Re: Tract 8 West bluff Center, Traffic Circulation Layout
Engineer's Stamp dated 11-28-07 (H-11/D059C)

**RE: Tract 8 West Bluff Center Subdivision, Traffic Circulation Layout
Engineer's Stamp dated 10-9-07 (H-11/DO59C)**

Re: Westside Retail, Tract 8 West Bluff Center, Grading and Drainage Plan
Engineer's Stamp dated 11-28-07 (H-11/D059C)

**Re: Tract 8 West Bluff Center Subdivision, Traffic Circulation Layout
Engineer's Stamp dated 11-16-07 (H-11/D059C)**

LEFT TURN EXHIBIT

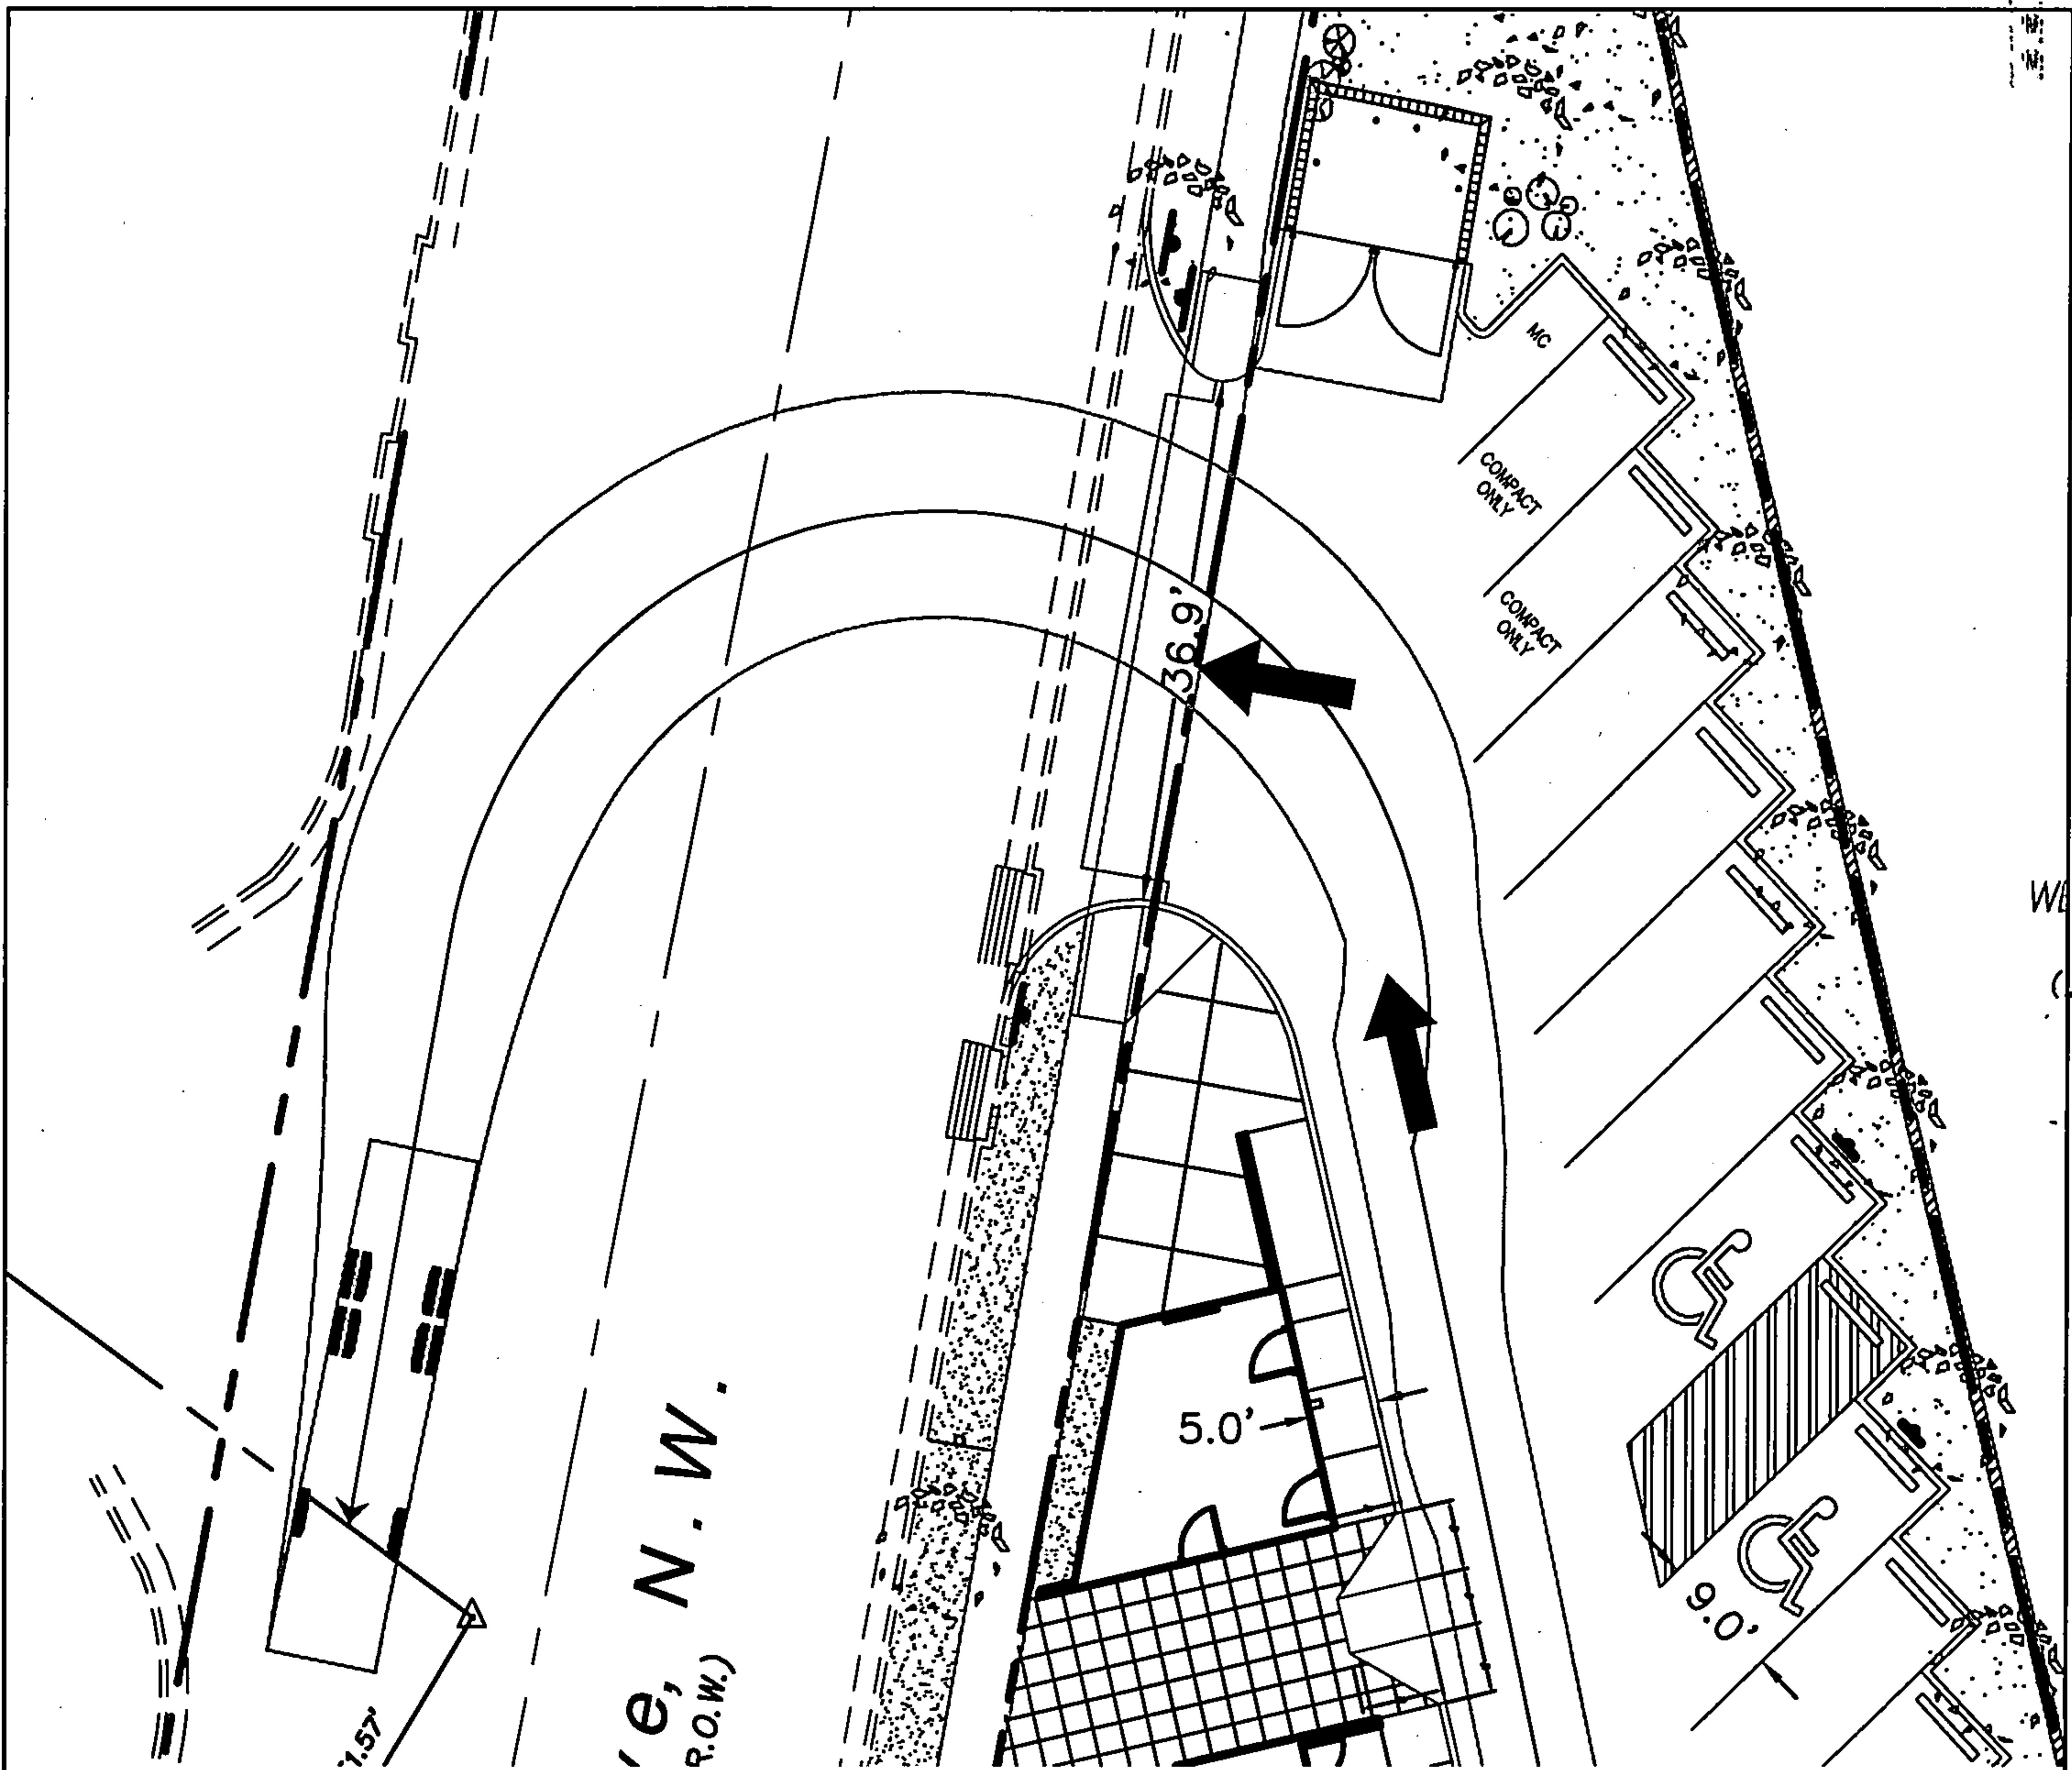
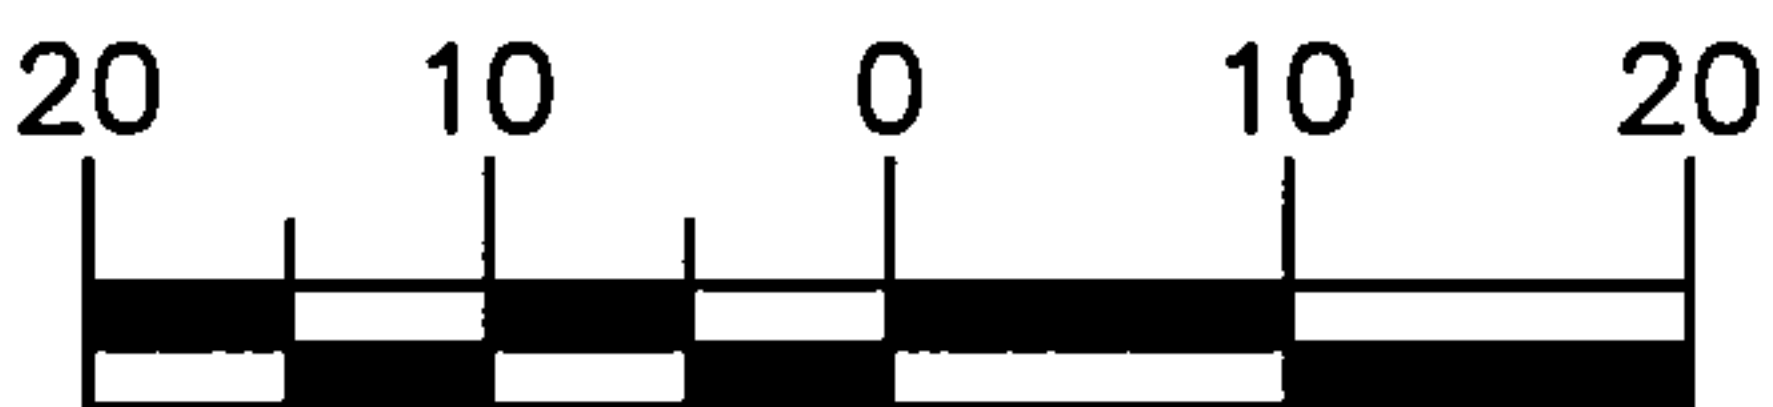
- 1) At the exit onto Corona, the minimum end aisle radius will need to be 15'.
The exit onto Corona was designed to minimize the disturbance to the existing curb inlets in Corona. The northern inlet will be modified to a Type "D" inlet, leaving the southern inlet intact. In order to accomplish this, the proposed curb will need to tie into the existing curb between the two inlets. Incorporating a 15' radius curb would necessitate reconfiguring both inlets. In lieu of a 15' radius curve we propose a compound curve consisting of a 15' radius followed by a 10' radius tying into the existing curb in Corona. The driveway cut is a one-way exit only. Therefore, there will be no right turn movements from Corona into the site along the 10' radius curb. Vehicles exiting the site onto southbound Corona will not be affected by the 10' radius, due to the width of the driveway out. An Auto turn simulation of a City of Albuquerque trash truck exiting the site and making a left hand turn onto Corona is attached for reference.
